RE: Starbucks
4301 San Mateo Blvd. NE
Request Permanent C.O. – Accepted
Engineers Stamp Date 2/9/15 (G17D006C)
Certification Dated 10/23/15

RE: Starbucks
4301 San Mateo Blvd. NE
Request Permanent C.O. – Not Accepted
Engineer's Stamp Date 2/9/15 (G17D006C)
Certification Dated 10/23/15

GRADING & DRAINAGE PLAN

C301

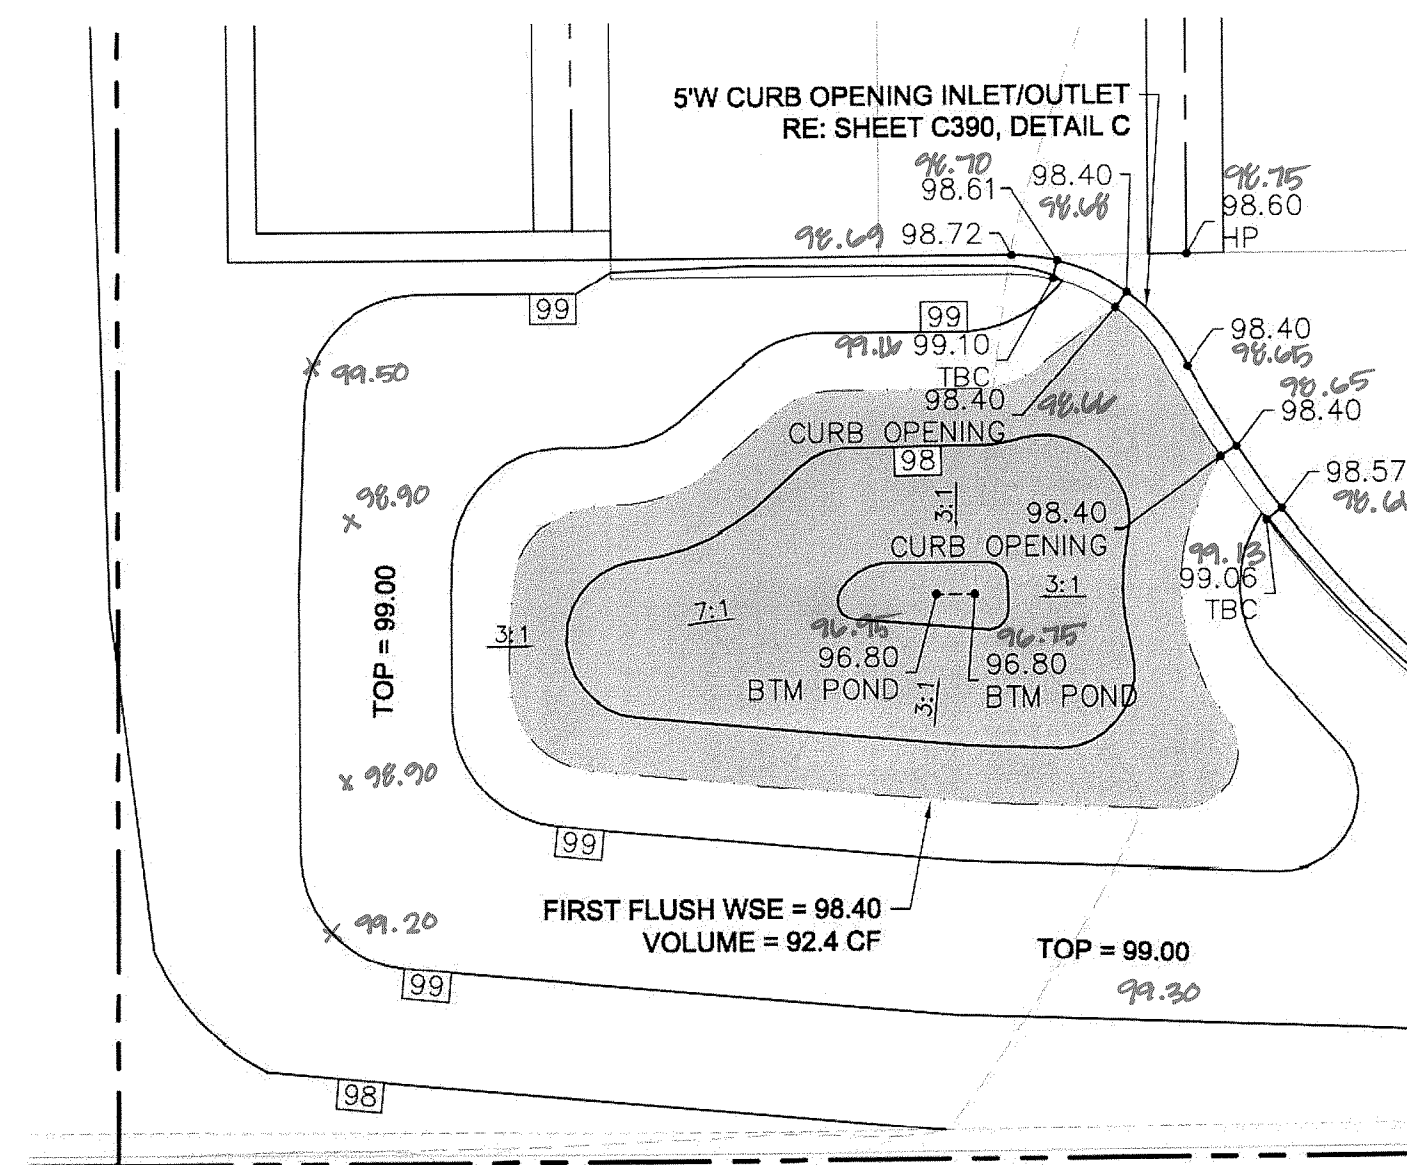
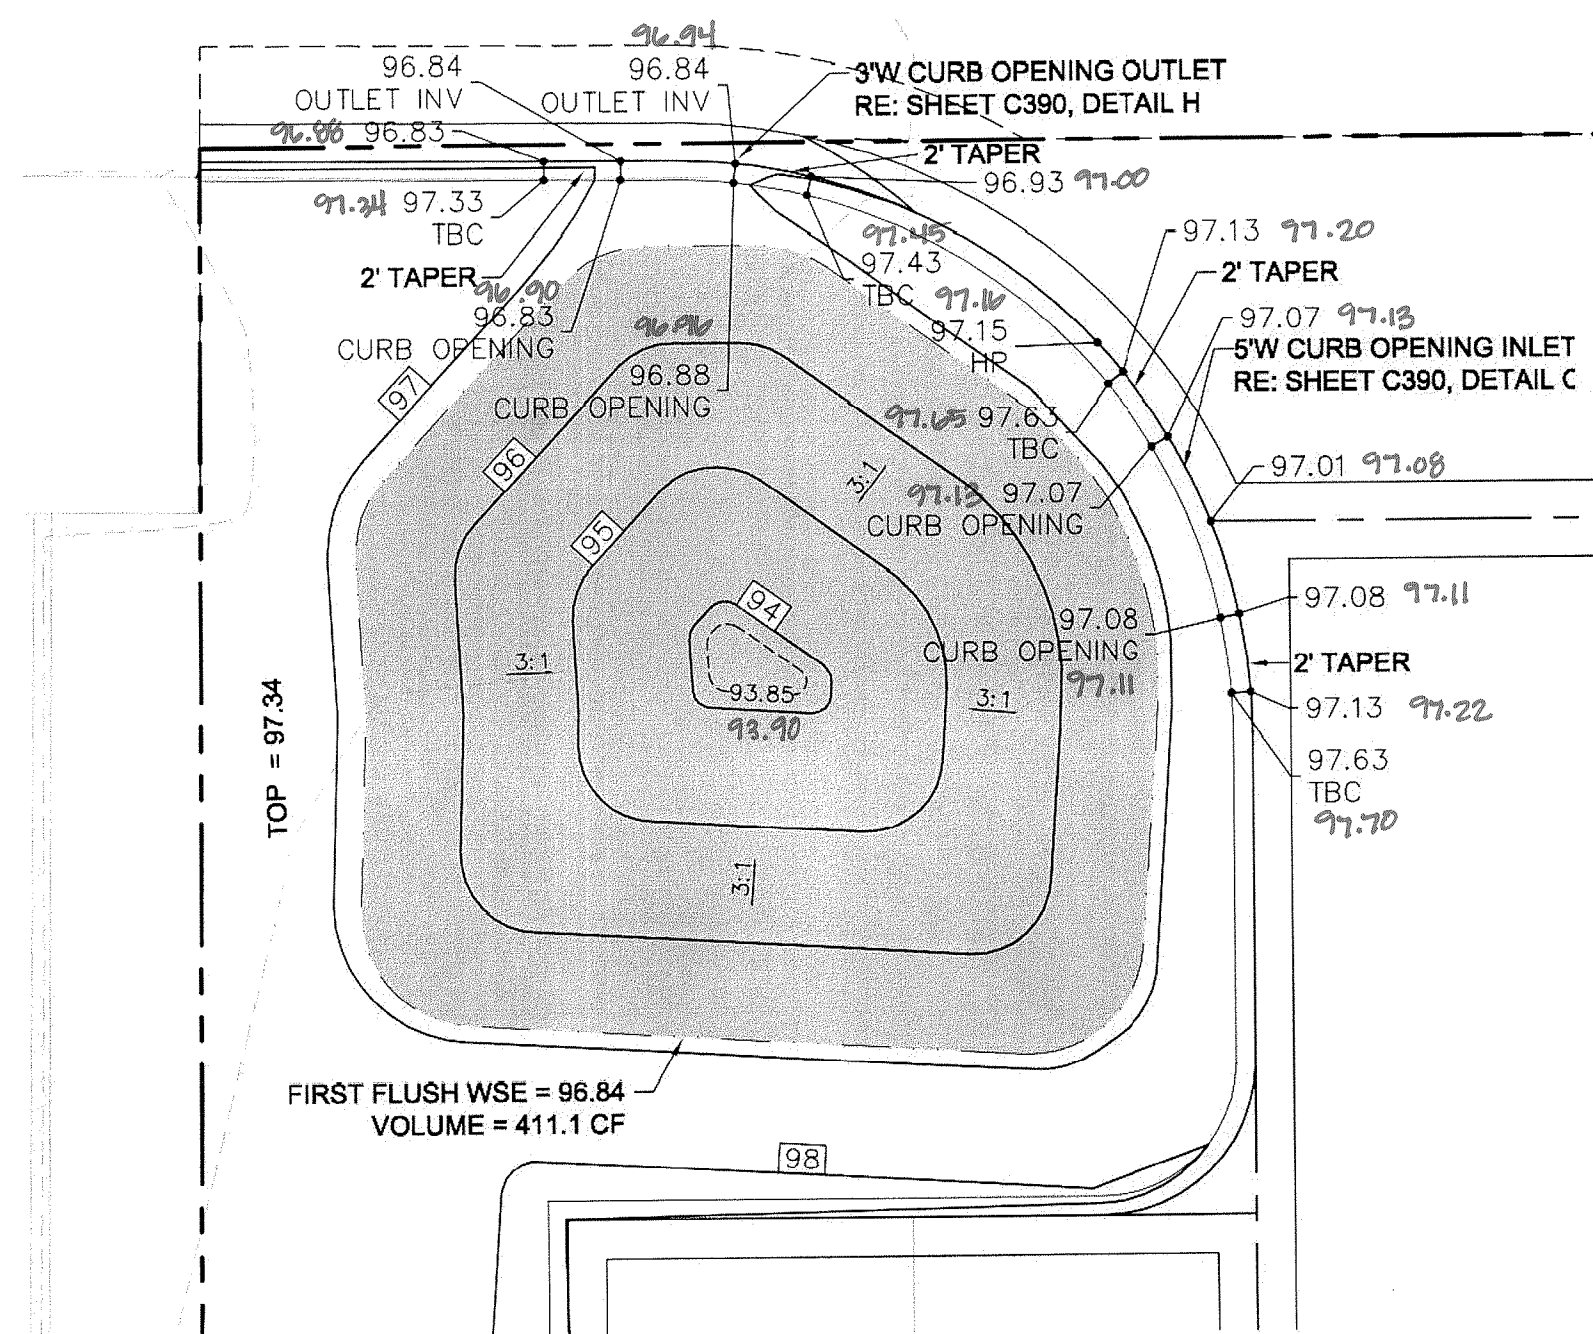
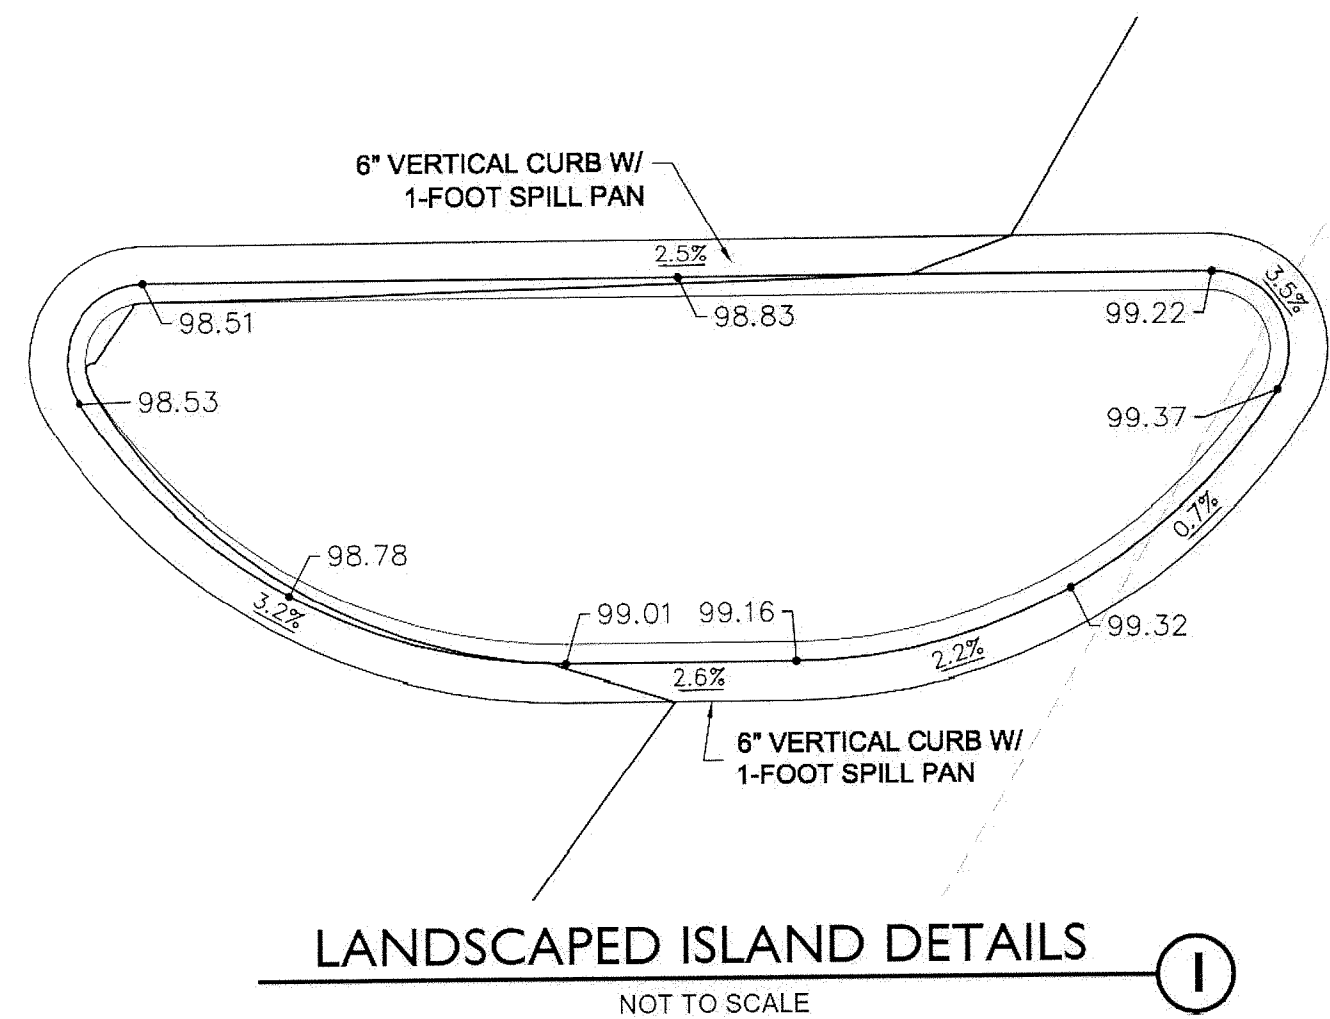
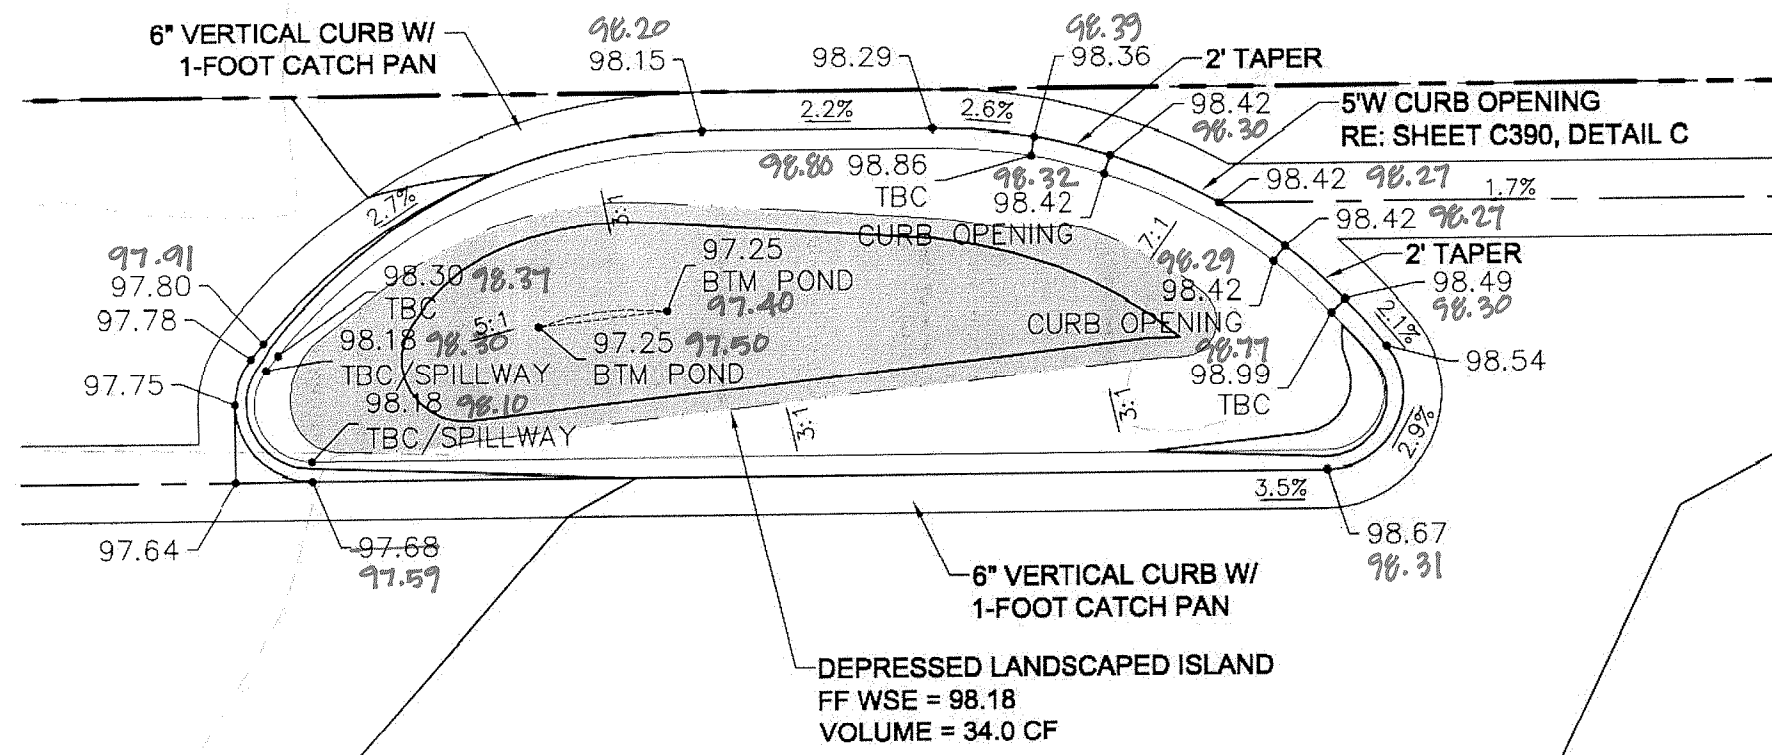
As the compliance language on the As-Built Sheet C301, stamped 10/23/15 indicates; these deviations from the grading and drainage design described on the approved plan(s) represent discrepancies which are minor in nature and/or should impact maintenance of the property rather than the overall drainage design intent.

Upon review it has been found that the ponds and depressed landscape island are complete. Concrete pan(s) are noted on the as-built as not constructed. Other deviations from the grading and drainage design described on the approved plan(s) represent discrepancies which are minor in nature and/or should impact maintenance of the property rather than the overall drainage design intent.

Based on the review described herein, of the information listed herein, and of this information only; it appears the completed improvements as described herein, associated with the grading and drainage aspects of the project have been graded and will drain in substantial compliance with the overall design intent of the approved plan(s).

SIDEWALK CULVERT
NOT TO SCALE

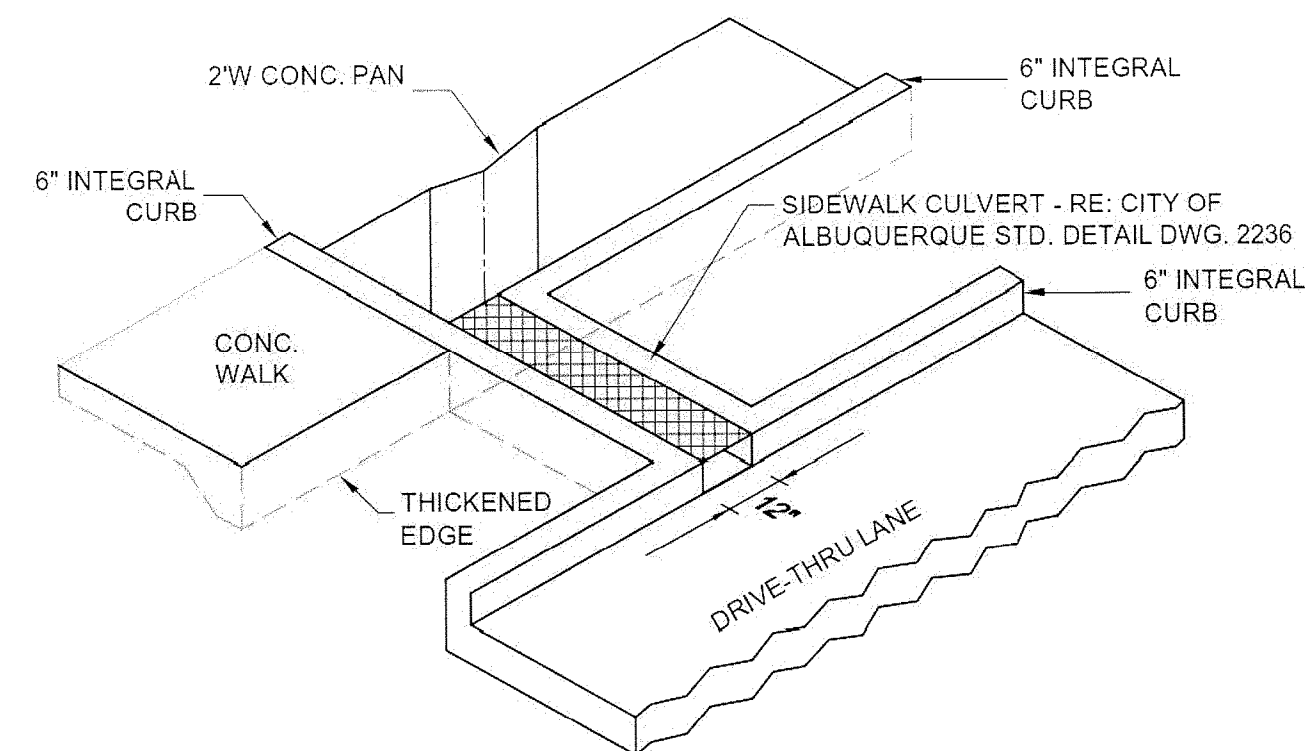
- The concrete sidewalk culvert is not within a paved pedestrian access, but is rather within a landscape area. Therefore pedestrian access across the top of the culvert by use of a steel plate is unnecessary.
- Based on the as-built field shots it appears there is adequate fall from the outlet of the sidewalk culvert across the adjacent downstream parking area. Therefore the 2' wide pan is unnecessary.
- As clarified in separate correspondence, the city's concern is in regard to the 6" curb opening on the "east" end of the building. Inclusion of a 6" curb opening may have provided additional drainage benefits to the adjacent landscape area; however, the lack of such an opening serving a relatively small tributary area should not significantly alter the overall design intent of the grading and drainage aspects of the project as described on the approved plan(s).
